Agenda
Planning Commission
Council Chambers
Wednesday, May 20, 2015 – 7:00 P.M.

SKETCH PLAN: CRITERIA AND REVIEW §122-126(19), §122-128

STAFF RECOMMENDATIONS: SKETCH PLAN

Figure 1: Lot outline, zoning, and building footprints

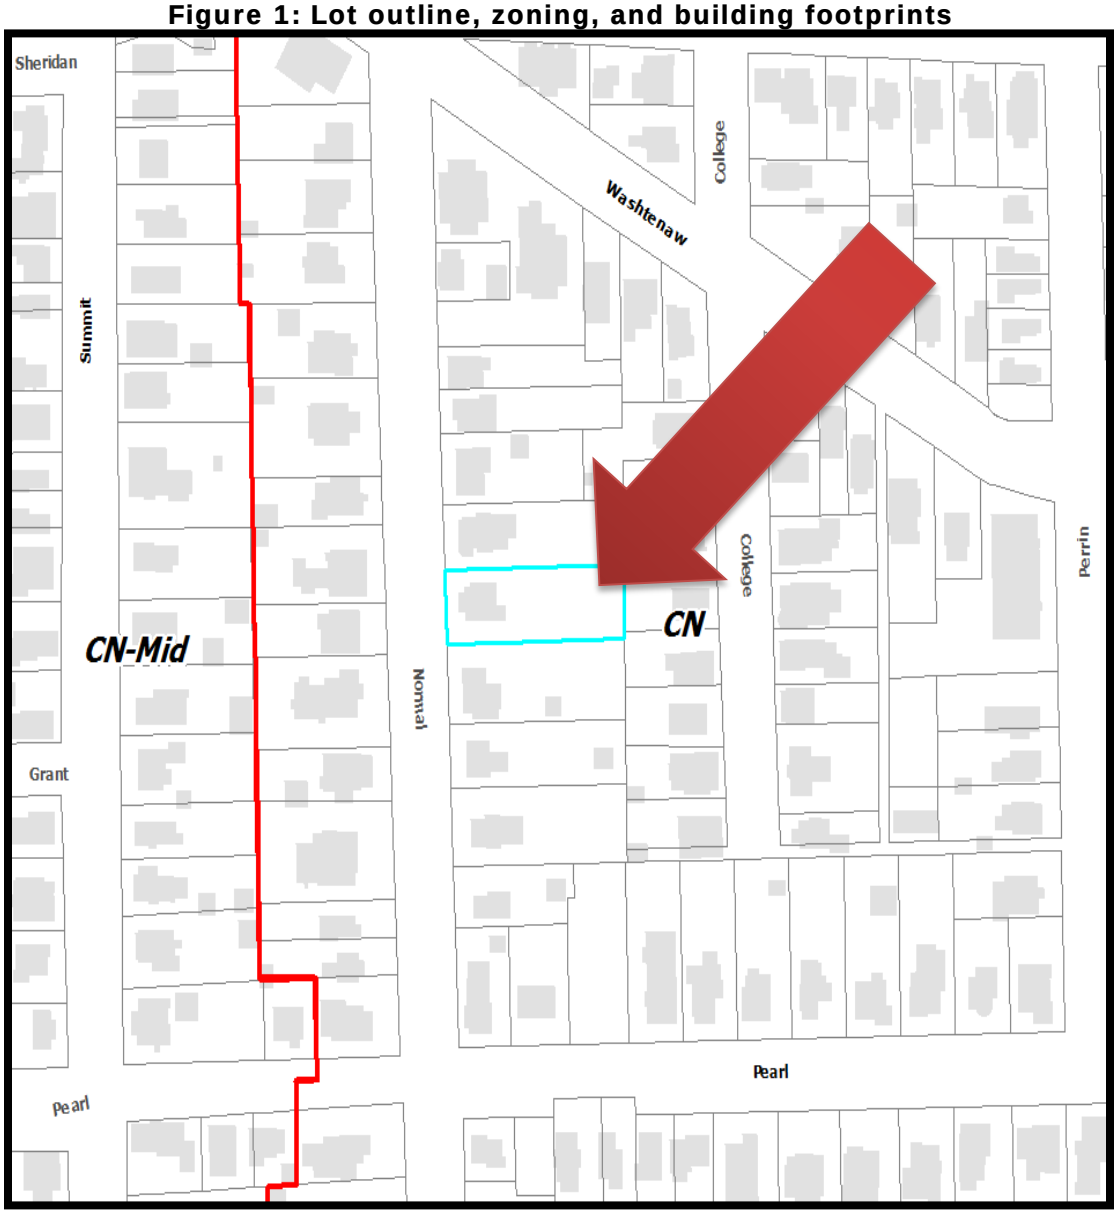
1. There is a 2 car garage shown on the sketch plan; as the sketch plan provided is a mortgage survey from 1981 and the garage no longer exists, please provide an updated, dimensioned sketch plan.
2. Any signage proposed on site must first obtain a sign permit.
3. Applicant to submit floor plan (sketch acceptable) of current interior layout. Should any renovations be proposed, building permits must be pulled and all applicable building and fire codes be followed.
4. Submit resident manager information with updated sketch & floor plans; provide at rental inspections and upon request by the City.

Items to be Addressed: Submit full plan for parking lot.
